**ON-SITE SEWAGE DISPOSAL SYSTEM
HOWARD COUNTY HEALTH DEPARTMENT
BUREAU OF ENVIRONMENTAL HEALTH**

6680 Guilford Road (Art Studio)

PARTIAL
 SITE PLAN 1" = 20' HEALTH DEPT.
 #6680 GUILFORD ROAD CLARKSVILLE HOWARD COUNTY MD 21029
 LOT # 10 (MAP 35 - GRID 17 - PARCEL 300) GROUP B1
 ZONING: RR200 PLAT # 6665 AREA = 24+ ACRES
 ELEC. DIST. B
 NOTE: EXISTING SITE INFORMATION FROM LOCATION SURVEY BY KIPPE CONSULTANTS (1980)
 IS PROVIDED BY THE OWNER.
 (TOPOGRAPHICAL DATA: APPROXIMATED FROM COUNTY COMPOSITE MAP #180)
 SEE OVERALL SITE PLAN ON SEPARATE SHEET
 SEE SEPARATE SHEETS FOR SITE SPECIFICATIONS & DETAILS
 SEE COVER SHEET FOR GEN. NOTES & PROJECT OVERVIEW
 SEE "PERC CERTIFICATION PLAT" PREPARED BY
 SHANBERGER & LANE · ELLICOTT CITY MD

PROPOSED ADDITION TO THE
 STRAIN HOUSE

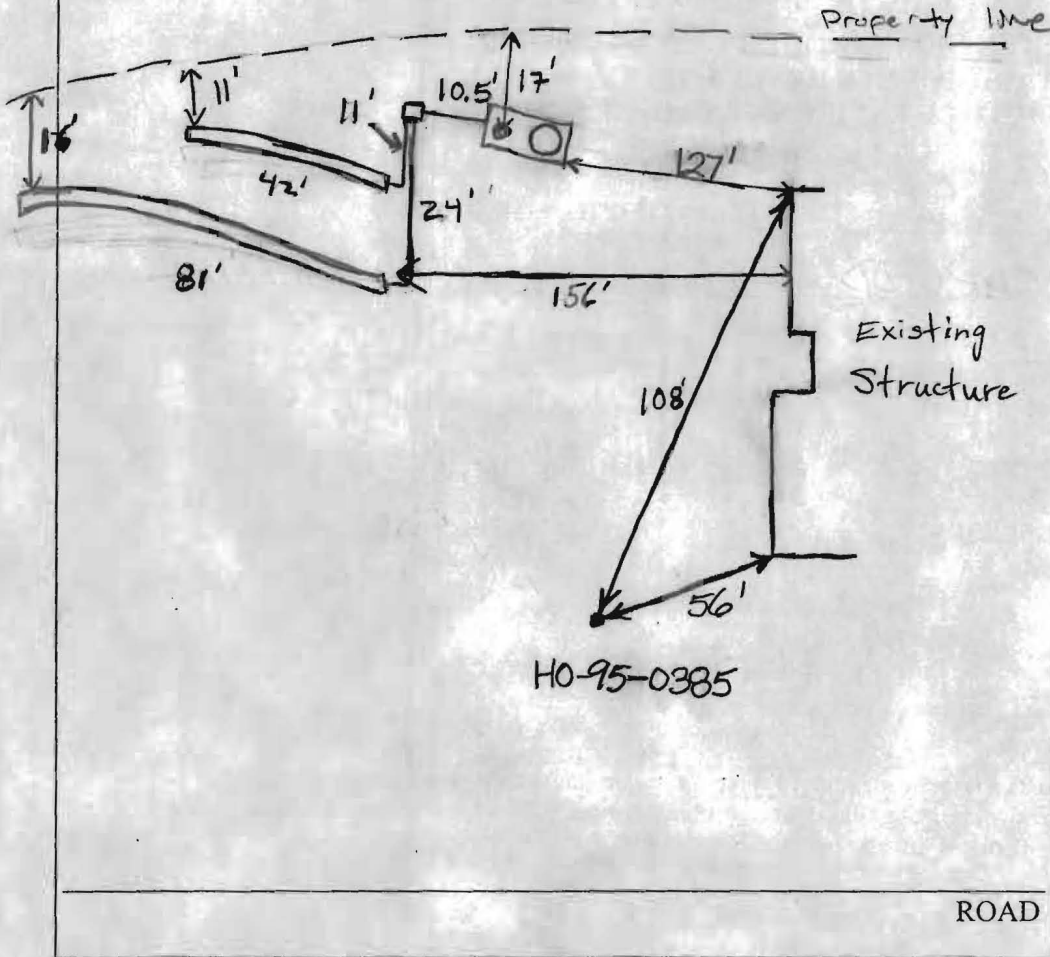
TRENCHES:	Trench to be 3.0 feet wide. Inlet <u>3.0</u> feet below original grade. Bottom maximum depth 8.0 feet below original grade. Effective area begins at 7.0 feet below original grade. 5.0 feet of stone below distribution pipe.
LOCATION:	<u>55 W 120 N 15 E</u> <u>875 577 U</u>
NOTES:	Reinforce the pipe coming out of the house and into the tank due to gravel driveway over top.

8/16/2006 Contractor said that he used 3 loads of stone for system (66 tons). I calculated ~4.5 loads of stone (minimum required). Told contractor that he has to demonstrate that he used a sufficient amount of stone for trenches. (BB) 8/24/06 Contractor changed story and said that there had also been gravel that was hauled in from his shop that was in addition to the 3 loads he

had previously mentioned. Still need building connection. (BB)

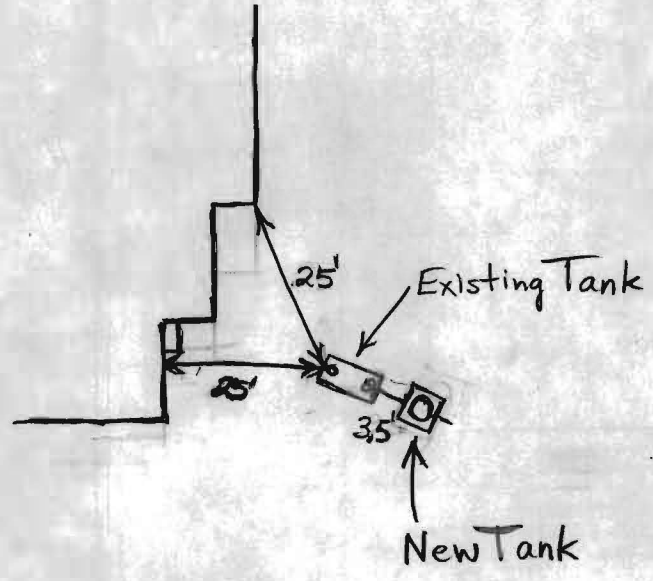
TRENCHES:	
LOCATION:	Existing house needs a new 1500 gallon septic tank or a 500 gallon piggy back tank to add to existing septic tank.
NOTES:	If new 1500 gallon septic tank is installed, old septic tank must be pumped and collapsed.

INSTALLATION 8/16/06 Additional 500 gallon tank connected to existing tank. O.K. to backfill. (BB)
